Question 2.5.2 No. 2 Reasonable Alternatives – Liquid Effluent Disposal

Question ER 2.5 No.1 Reasonable Alternatives – Alternate Plant Site

Question 2.5.2 Number 2 Reasonable Alternatives – Liquid Effluent Disposal

Question 2.5 No. 3 Reasonable Alternatives - Alternative Lixivants and Mining Methods

Figure 2.5-1

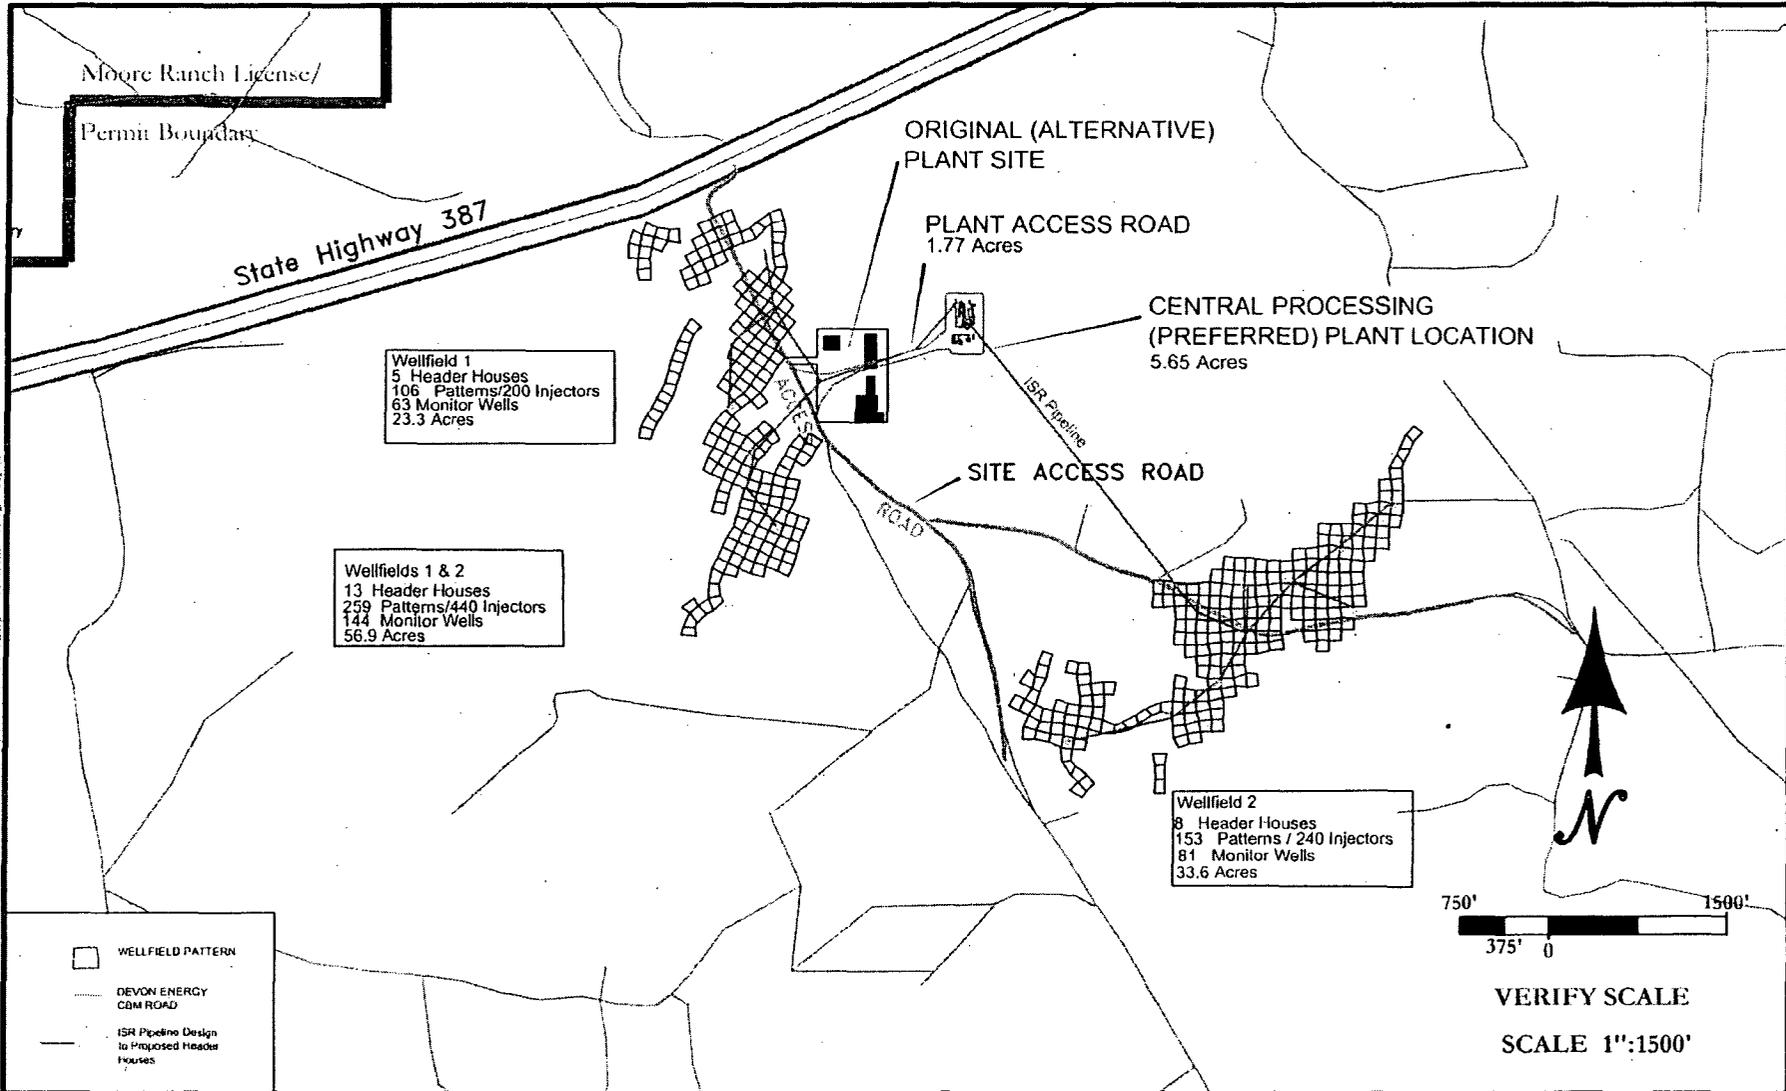
Information on other sites that were evaluated prior to picking the site where the project is to be accomplished. Also include information on the footprint, such as alternative plant locations, routes for roads, and building locations.

The Central Plant was initially proposed at a location which was situated approximately 700 feet to the west of the current proposed location, shown in Figure 1.2-4 of the Environmental Report. Since preparation of the Environmental Report, additional siting evaluations have been performed and a better location has been identified compared to the original proposed Central Plant site location. The current preferred Plant site is deemed the most suitable location primarily due to the existing topography and the minimal topographic changes required for the proposed layout of the plant infrastructure. Additional information on this evaluation and alternate site information including a new Figure 2.5-1 will be included in the revised Section 2.5 of this Environmental Report.

The site of the Moore Ranch Central Plant was initially planned at a location which was situated approximately 700 feet to the west of the current preferred location, shown in Figure 2.5-1. The current proposed plant site was deemed the more suitable location primarily due to existing topography, and the minimal topographic changes that would be required for the proposed layout to the plant infrastructure. The new proposed site location minimizes cut and fill, thereby minimizing the disturbance of natural ground. The revised site location, as with the alternate site location, is located to minimize environmental impacts in that it

will be in close proximity to the primary access road, it will avoid existing utilities, and its visibility from Highway 387 will be minimized.
